REPAIR TO CENTER SECTION BUTT RIB (PART NO. 415-13131 L & R)
UPPER FRONT COR.

ENGINEERING ORDER

TITLE: ASSEMBLY - CENTER SECTION (FUSELAGE & CENTER SECT. - WING)	ENGINEERING DEPARTMENT ALON INC. McPHERSON, KANSAS	DRAWING NUMBER F 13101	MODEL A2	E.O. NUMBER 5212C
REASON: TO PREVENT FATIGUE CRACKING OF END RIB OF WING CENTER SECTION IN SERVICE	V	CHANGE EFFECTIVE ON A 30 & ON		REQUESTED BY: F.A.A.
THIS NOTICE TO BE USED AS PART OF DWG AND SUPERSEDES AS SHOWN		REV. A CLASS II	REV. B A-30 & ON REVC A 30 & ON	F. A. A. MAJOR <input type="checkbox"/> MINOR <input checked="" type="checkbox"/>

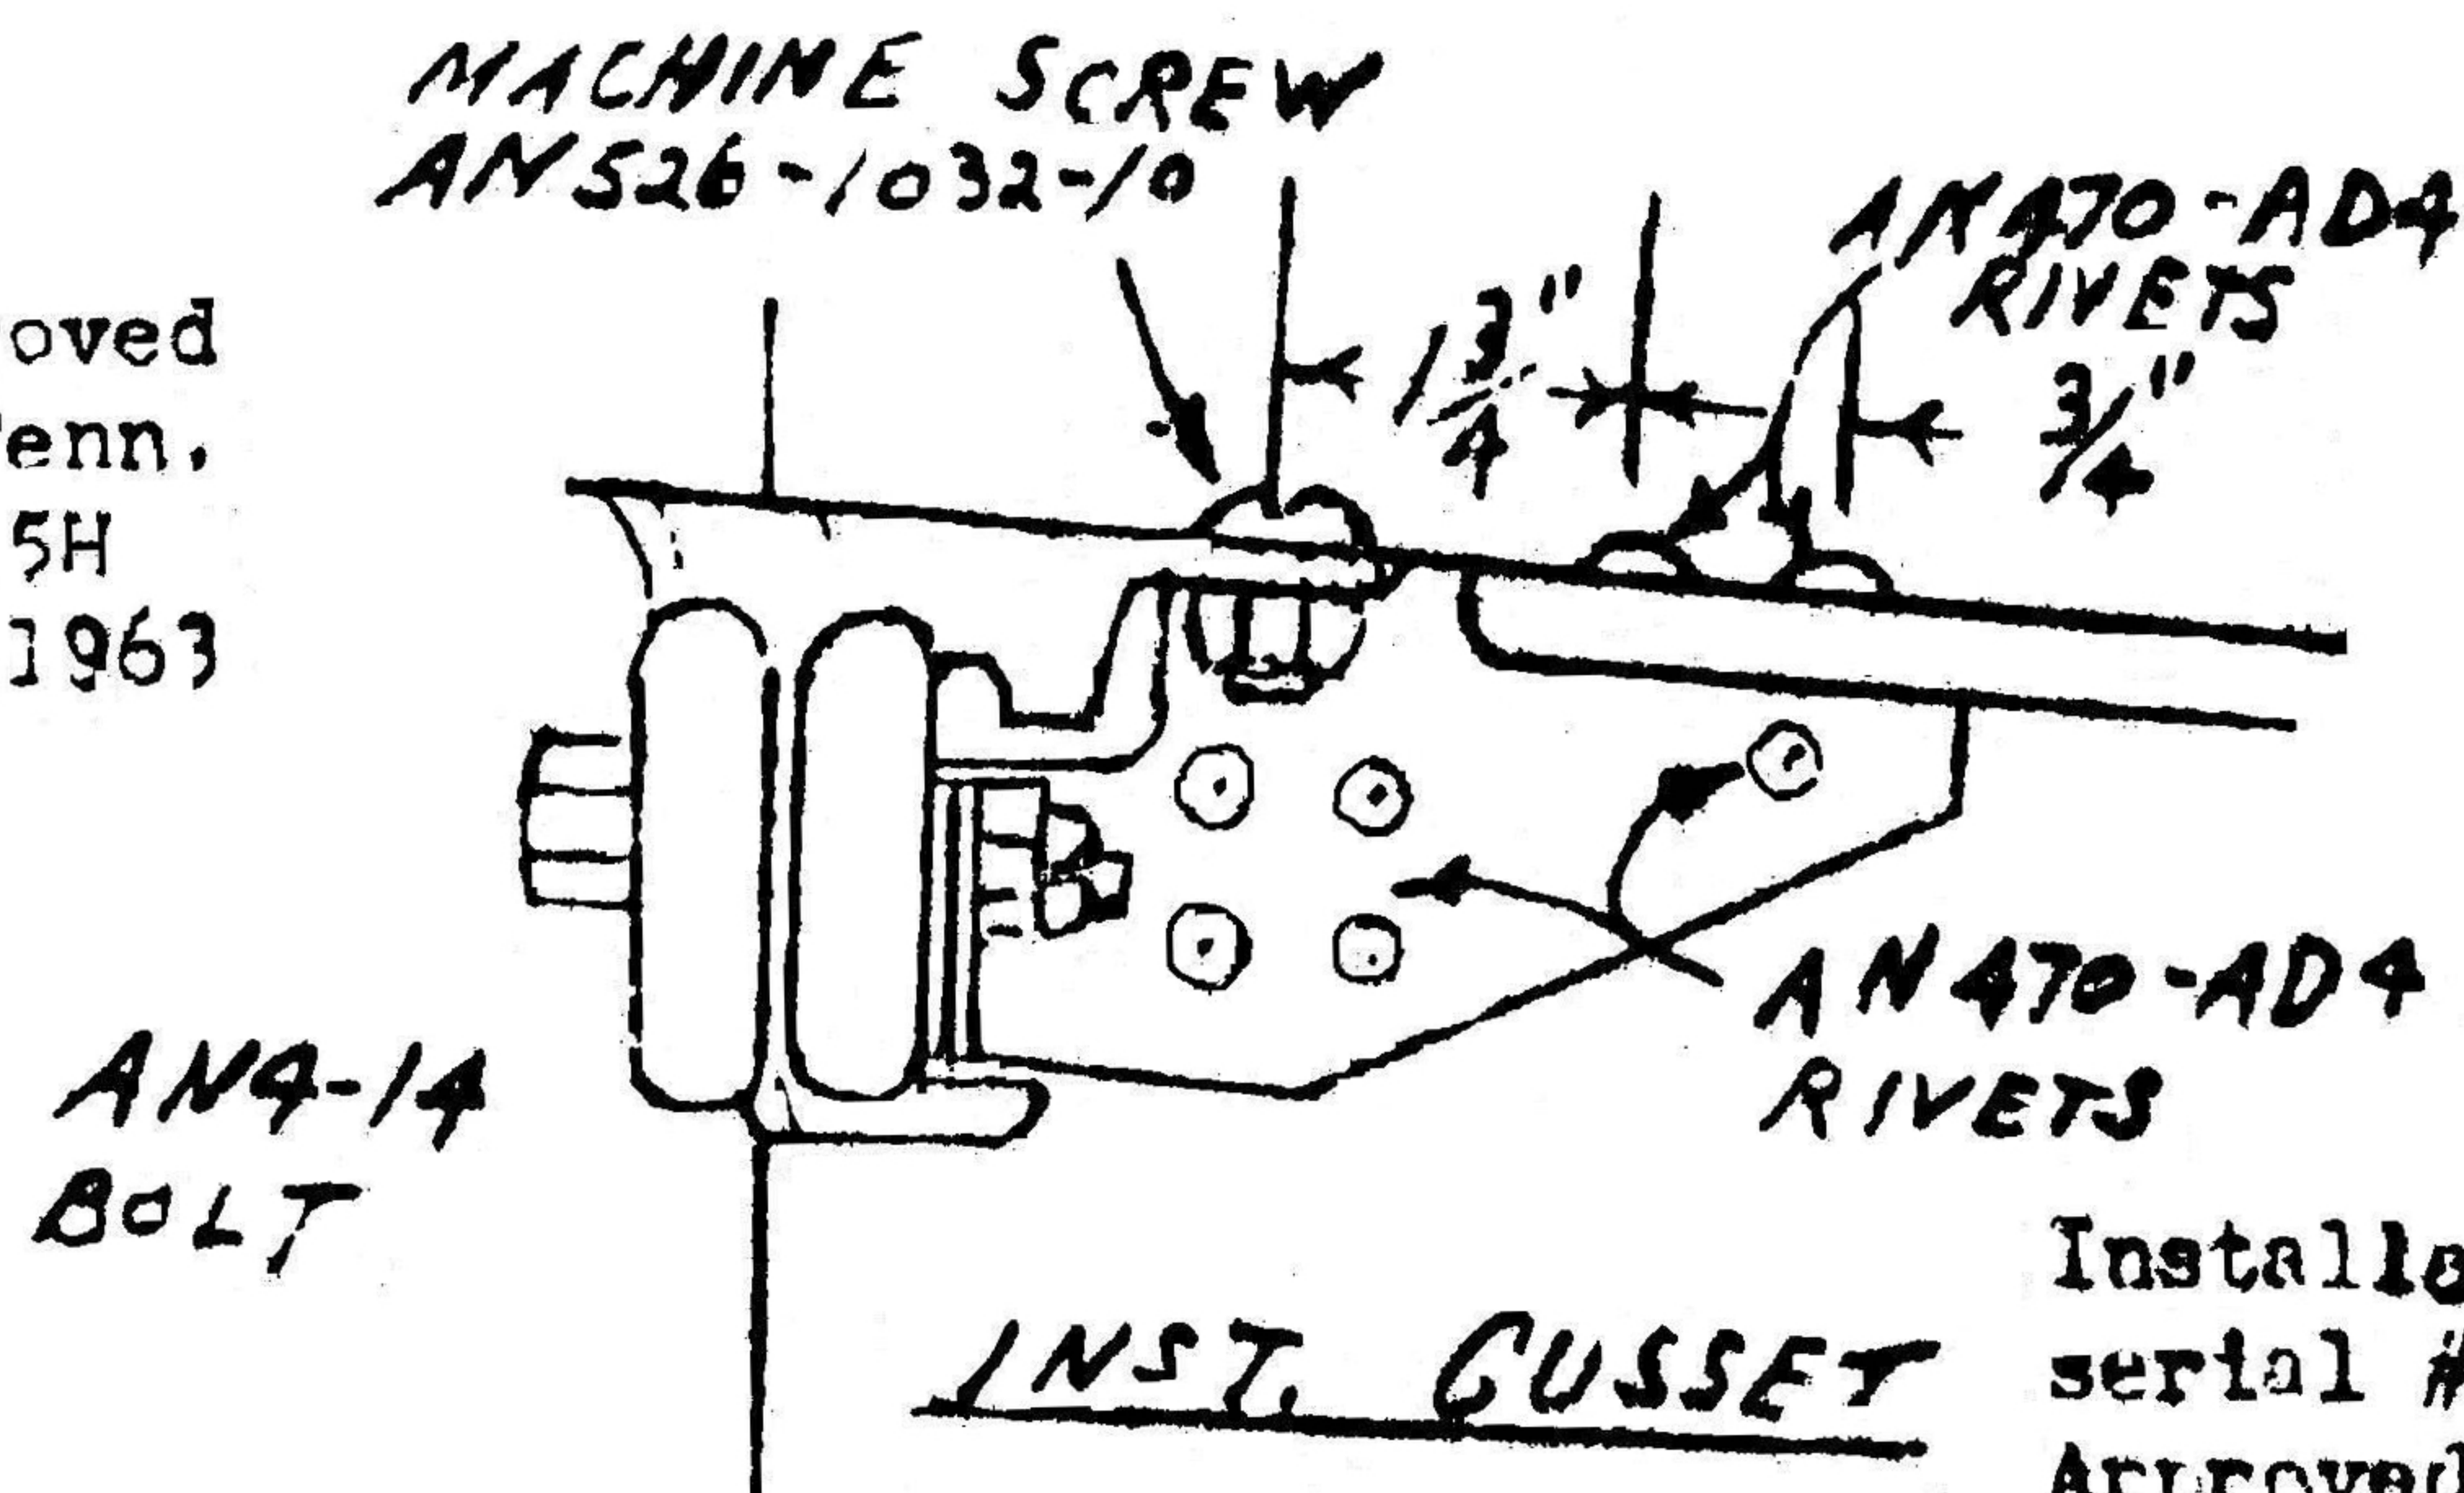
Stop drill the crack with #40 drill, remove the AN4-14 bolt and AN526-1032 machine screw. Clamp the gusset into place. Drill the hole to reinstall the AN4-14 bolt and AN525-1032 machine screw. Use #30 drill for the five (5) holes for the AN470-AD4 rivets to secure the gusset to the flange and gusset as shown on the drawing. Remove the gusset and remove all the drill chips. Wet zinc chromate the gusset and rib area. Replace the gusset and reinstall the AN4-14 bolt and secure with AN310-4 nut and key. Install the AN325-1032-10 machine screw, then secure with AN 960-10 washer and AN365-1032 nut. Rivet the gusset to the rib web with (5) five AN470-AD4 rivets. Then rivet the alum. shim rib flange and gusset with (2) two AN470-AD4 rivets.
